Miawpukek First Nation  
Comments on the Valentine Gold Environmental Impact  
Statement  
December 23, 2020

## 2.0 Comments on the Valentine Project Environmental Impact Statement

**Figure 3.** Geographic boundaries for fish and fish habitat assessment areas (EIS, Figure 8-1: Marathon, 2020).

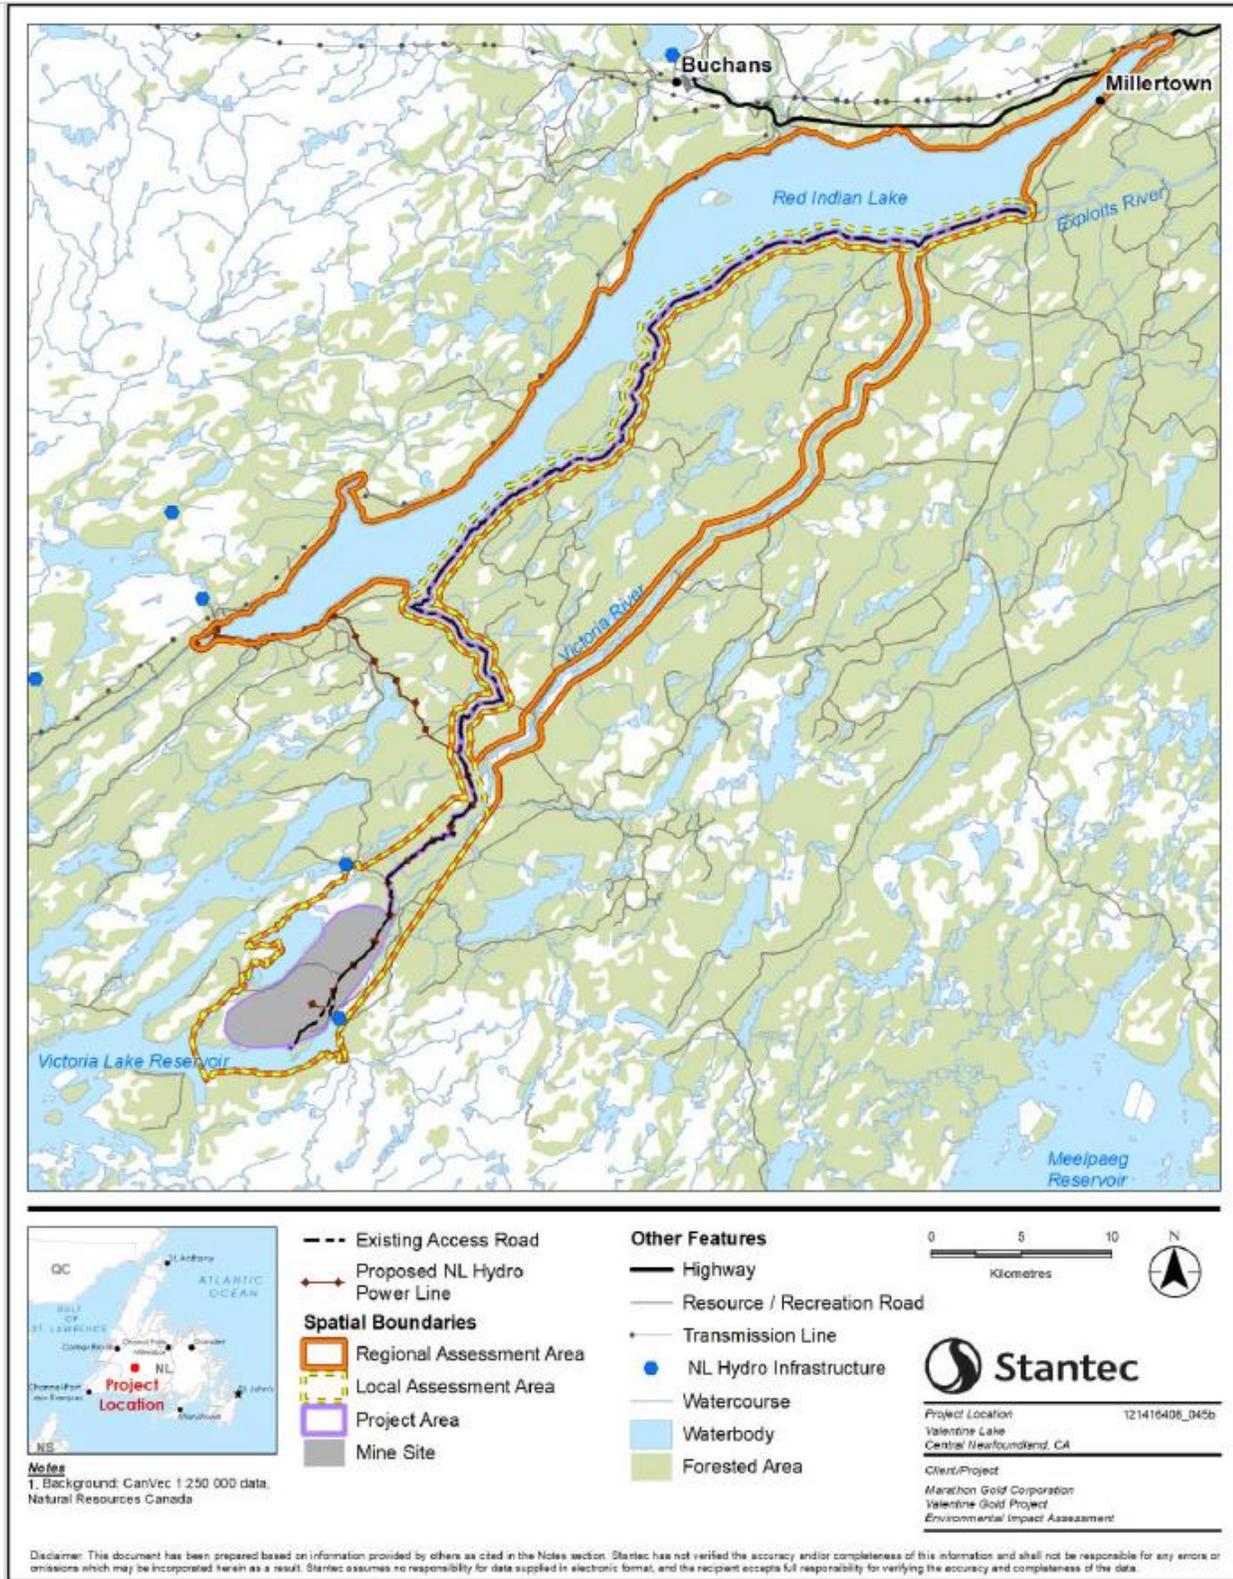
Comment #	Description	Request
<p><b>MFN Comment 19, Figure 8.1</b></p>	<p>The size of the LAA and RAA for fish/fish habitat are exceedingly small given the footprint of the potential and cumulative effects of the Project. The LAA and RAA appear to have been chosen in a manner that is not conservative and assumes that the potential effects predicted are the worst-case scenario. This is not reasonable, as the predicted effects should be based on the most likely scenario. Further, the RAA should be scoped to an area where the effects of accidents/malfunctions and cumulative effects could occur. Specific issues with the LAA and RAA include:</p> <ul style="list-style-type: none"> <li>• the LAA does not include the full area of Victoria Lake Reservoir, despite being a receiver for discharge/runoff/seepage from the Leprechaun Pit, mine rock stockpile and TMF. Fish in these areas are highly mobile and thus the direct effects on fish and fish habitat must include the full Victoria Lake Reservoir.</li> <li>• The LAA does not include areas of Victoria River downstream of the Victoria Dam, despite the potential impacts of spills and seepage from the TMF. This includes a substantial stretch of river from the Victoria Dam to the confluence with stream 35. These areas are immediately downstream of project infrastructure and may be impacted by reduced flows, seepage, runoff, and spills, necessitating inclusion in the LAA. It appears that this area was only observed using fly-overs.</li> <li>• The RAA does not include area downstream of Victoria Lake Reservoir which may be impacted by contaminants from TMF discharge (operations/closure), spills/accidents/malfunctions from equipment or infrastructure at the Leprechaun complex (operations), runoff/seepage from the Leprechaun complex (operations and closure) and effluent/tailings from the filled Leprechaun pit (during closure).</li> </ul>	<p>The Proponent must expand the LAA and RAA as requested. This expansion should also be reflected in all parts of the EIS including:</p> <ul style="list-style-type: none"> <li>• Additional baseline studies necessary to characterize habitats within the LAA</li> <li>• Expanded effects assessment covering the larger LAA</li> <li>• Expanded monitoring programs, which would cover the LAA in areas in Valentine Lake, Victoria Lake Reservoir and Victoria River.</li> <li>• Increase the RAA to include Victoria Lake Reservoir and areas downstream to the Bay d’Espoir hydroelectric station.</li> </ul>
